LAND REDEVELOPMENT COMMITTEE

Date: 7 September 2026
Item 2.1: Lot 6 Victoria Street, Midland – Four- and Five-Storey Multiple Dwelling (Social and Affordable Housing) Development
Submitted by: Conor Ward

PLANNING ASSESSMENT

LANDSCAPE CONCEPT PLAN

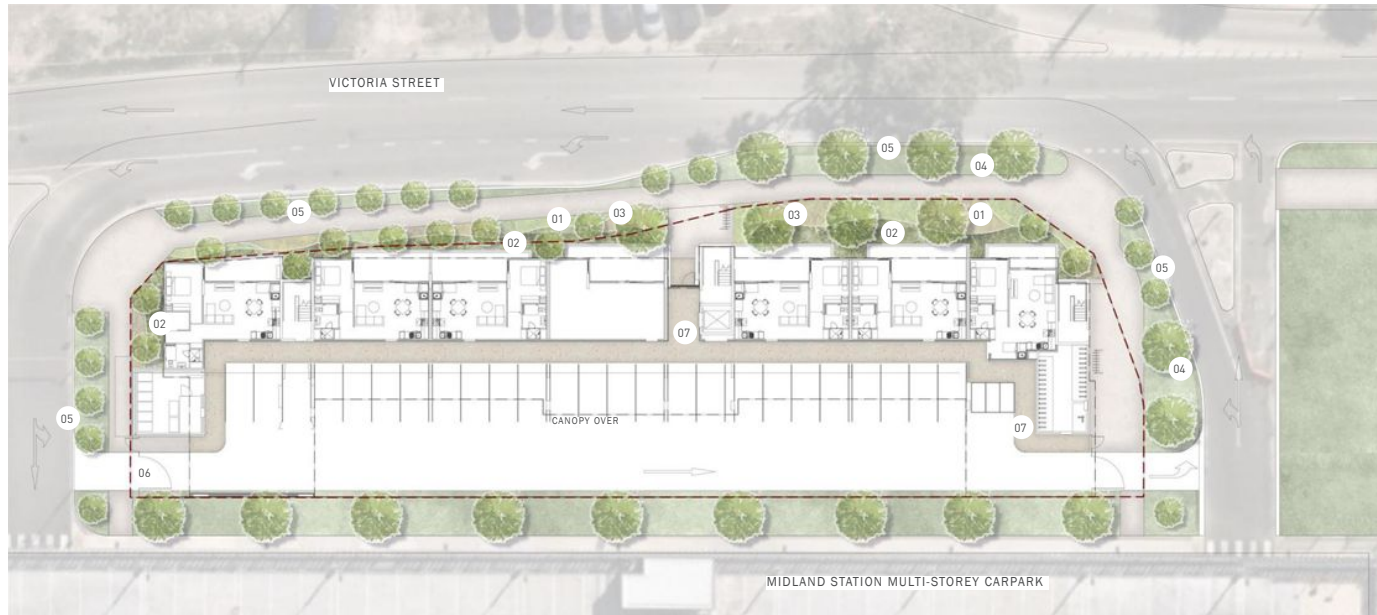
- **Landscape quality:** The success of the landscape response will depend on species selection, consideration of Midland's landscape context, and the careful alignment of trees to establish a consistent streetscape rhythm. The design of the southern fence including height, location and integration with the public open space are noted, and opportunities for landscape to play a stronger role in screening and security should be further explored.

- Review of the landscape design and species palette to better respond to the Midland context, including opportunities to incorporate contextually appropriate native species in place of, or alongside, exotic species.
- The green buffer to Victoria Street is positive and generous in scale. Further consideration should be given to increasing the use of medium and large canopy trees to strengthen shade, visual relief and rhythm of streetscape planting.
- The positioning and spacing of trees should be carefully considered to provide a consistent landscape rhythm and built form particularly along Victoria Street.
- Explore opportunities for the provision of climbers or other landscape treatments along the southern fence line adjoining the bus interchange to soften the interface and improve visual amenity.

4. A revised landscape plan detailing both soft and hard landscaping elements and ongoing maintenance and management requirements is to be provided at planning condition clearance (working drawings) stage and implemented thereafter, to the satisfaction of DevelopmentWA, in consultation with the City of Swan. (Refer to Advice Note e)

- e) With regard to Condition 4, the revised Landscaping Plan is to include the following:
- i. selection of species (suitable to Perth's climate), sizes, and types of plantings;
